ADDENDUM
PLANNING DIVISION REPORT
DEPARTMENT OF PLANNING AND COMMUNITY
AND ECONOMIC DEVELOPMENT
Of July 30, 2008

RE: I.D. #10643: Zoning Map Amendment I.D. 3367 To Rezone 515 S. Midvale Boulevard from PUD-GDP to PUD-SIP

SUBJECT: **Referral of 515 South Midvale Boulevard – PUD (GDP-SIP) – Staff Comments on Plan Commission Referral to Review Plans for Midvale Blvd Driveway Alternative**

Level Plan

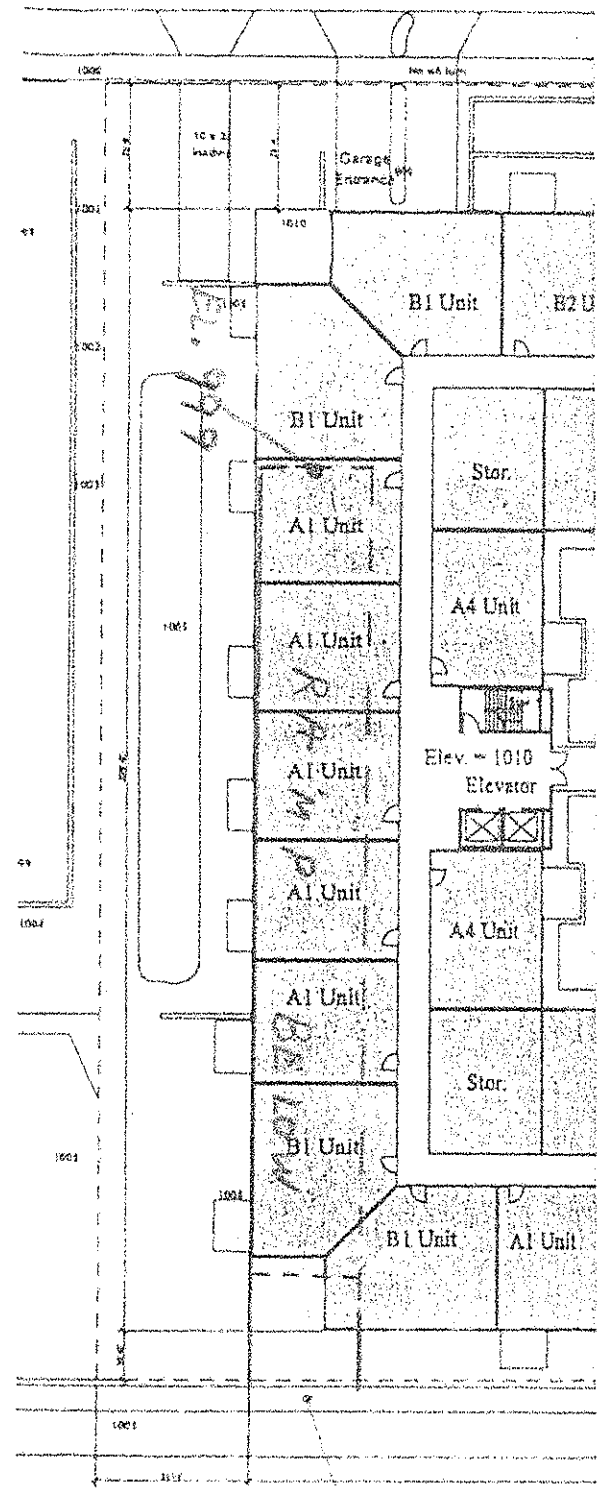
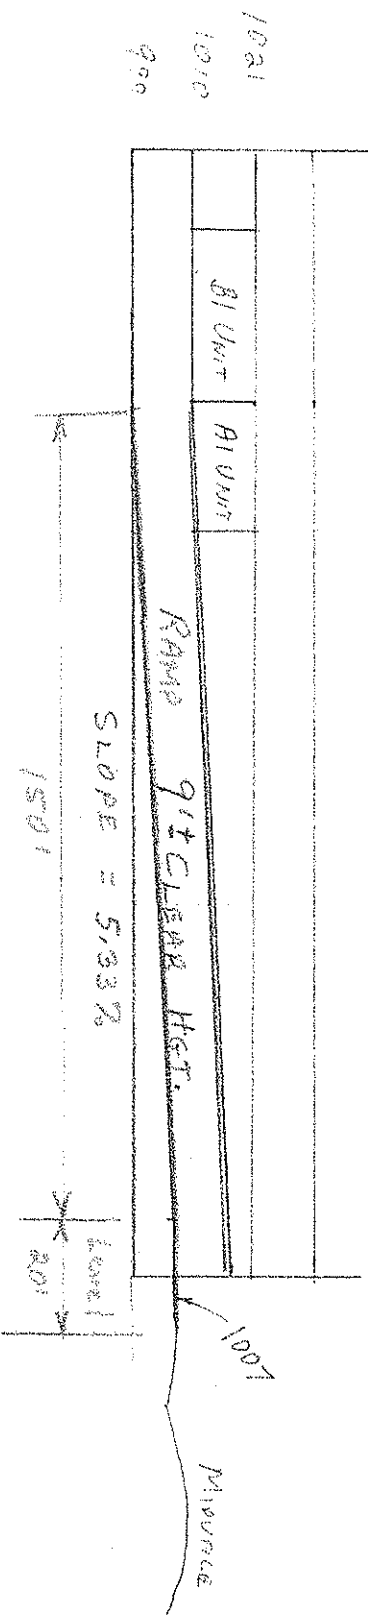
A sketch prepared by Mr. Reichel of a potential Midvale Blvd entrance to Phase II **internal** to the building with a slope of 5.33%.

150' @ 5.33% Slope

CSC EXHIBIT

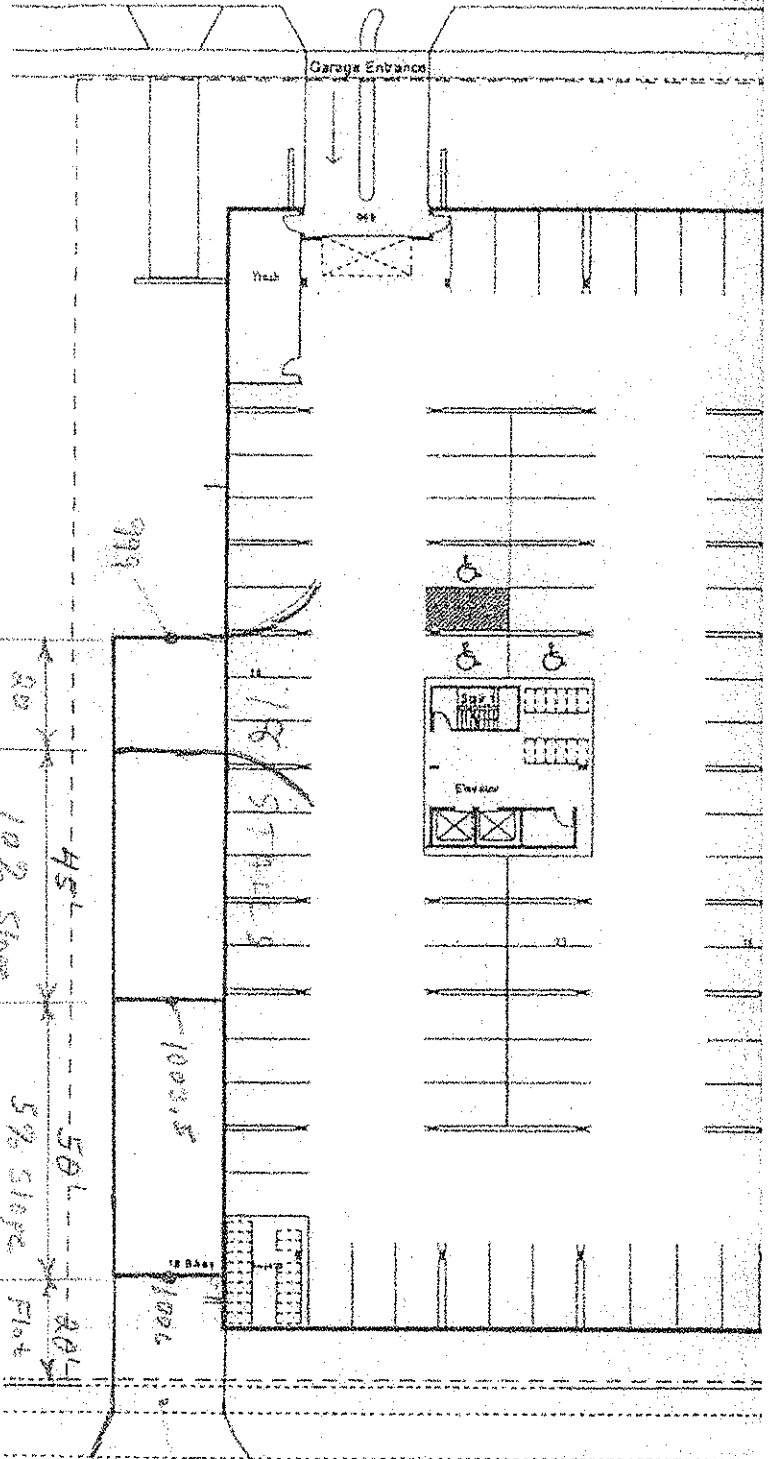
A sketch prepared by Mr. Reichel of the impact of the above interior garage entrance on the first floor apartments.
